Access Compliance Report

Public Rights-of-Way

(Accessible Street Parking)

Intersection ID: 13846	Main Street: CAMDEN_RD	Location: N/A
ADA ID: 4E922819416D	ParkingType: ParaPark	Overall Compliance: No
		Severity Score: 0.0
Codes/Mitigation Info/Possible Solution		Field Measurements/Component Compliance

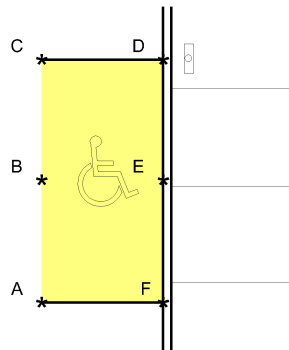
Compliance	Description	Data	Compliance	Description	Data
N/A	Parking Spot At End of Block?	Yes	Yes	Accessible Route?	Yes
Yes	Adjacent Sidewalk Width (in)	92.0	No	Access Aisle Marking?	No
No	Adjacent Sidewalk Slope (%)	4.0	N/A	Access Aisle Width (in)	N/A
No	Adjacent Sidewalk XSlope (%)	2.2	N/A	Access Aisle Length (in)	N/A
Yes	Adjacent Sidewalk Clear of Obstr.	Yes	N/A	Access Aisle Location	N/A
	N/A	Parking Spot Width (in)		74.0	
	N/A	Parking Spot Length (in)		254.0	
	N/A	Van Accessible?		N/A	
	No	Curb Ramp?		No	
	N/A	Identification Sign?		N/A	
	N/A	Sign Height (in)		N/A	
	N/A	Vertical Clearance		N/A	
	N/A	Parking Meter?		N/A	
	N/A	Parking Meter Height (in)		N/A	
	N/A	Meter Operable Parts?		N/A	
	N/A	Meter Clear Space?		N/A	
	N/A	Meter Clear Space Slope (%)		N/A	
	N/A	Meter Clear Space XSlope (%)		N/A	
	N/A	Meter Forward Reach?		N/A	
	N/A	Meter Forward Reach (in)		N/A	
	N/A	Meter Parallel Reach?		N/A	
	N/A	Meter Parallel Reach (in)		N/A

N/A	Parking Space/Access Aisle Slopes (%)					
	C Slope (%)	3.6	D Slope (%)	10.1	I Slope (%)	N/A
	B Slope (%)	3.0	E Slope (%)	2.9	H Slope (%)	N/A
	A Slope (%)	2.8	F Slope (%)	10.8	G Slope (%)	N/A
N/A	Parking Space/Access Aisle XSlopes (%)					
	C XSlope (%)	4.6	D XSlope (%)	2.0	I XSlope (%)	N/A
	B XSlope (%)	5.5	E XSlope (%)	9.5	H XSlope (%)	N/A
	A XSlope (%)	7.5	F XSlope (%)	3.9	G XSlope (%)	N/A
					L Slope (%)	N/A
					K Slope (%)	N/A
					J Slope (%)	N/A
					L XSlope (%)	N/A
					K XSlope (%)	N/A
					J XSlope (%)	N/A

Advise relocating to an area with maximum 2% slopes
